Three Mile Island Nuclear Station Unit 1 (TMI-1)
 Operating License No. DPR-50
 Socket No. 50-289
 EFW System Seismic Interaction

Seismic Resistance of Auxiliary Steam LineItem

EFW Pipe Supported From Stairs Inside Containment

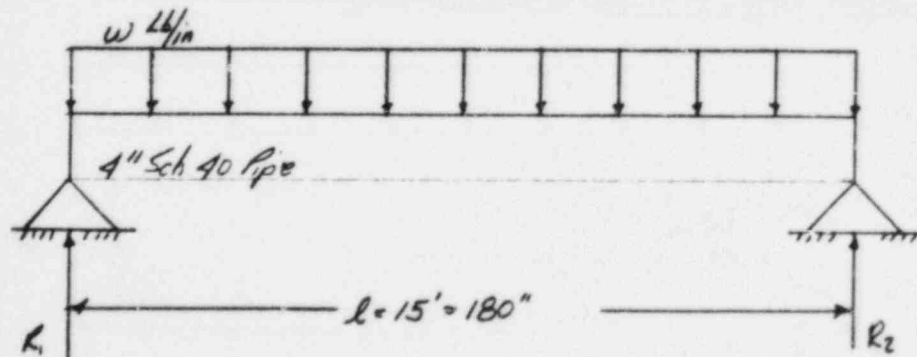
Provide additional information to clarify and justify the calculated Auxiliary Steam Line natural frequencies (for both horizontal and vertical directions) stated in Reference 1 are the bounding conditions for the as-built Auxiliary Steam Line whose failure could produce a harsh environment in which the EFW system must operate. Expand your response to include the evaluation of the pipe supports and their attachments to the building for an SSE condition, specifically, the compression loads applied to the supports during an SSE seismic event.

This equation shows that the natural frequency of a pendulum is independent of its mass and the only parameter is the length of the threaded rod, which varies from 7 to 10 ft approximately. The results of this analysis indicate that the maximum and minimum pendulum frequency for the system is 0.3613 Hz and 0.2794 Hz respectively. In addition to calculating the pendulum frequency for the system, the building's first natural frequency of 13.15 Hz was obtained from the response curve for the building. The building's natural frequency was compared with the maximum and minimum pendulum frequencies of the system to determine if the three frequencies coincide. Based on this comparison, it is evident that the building will be incapable of exciting the piping during a horizontal seismic event (i.e., the piping would tend to experience a gentle swinging motion).

After obtaining the results for the horizontal seismic event, the analysis considered the effects of a vertical seismic acceleration on the system. The analysis considered a representative and maximum support span of 11.25' and 15.0' respectively. For both cases the pipe was considered a uniformly loaded simply supported beam of length equal to the two above mentioned support spans. The first natural frequencies for these models were then calculated using the equation:
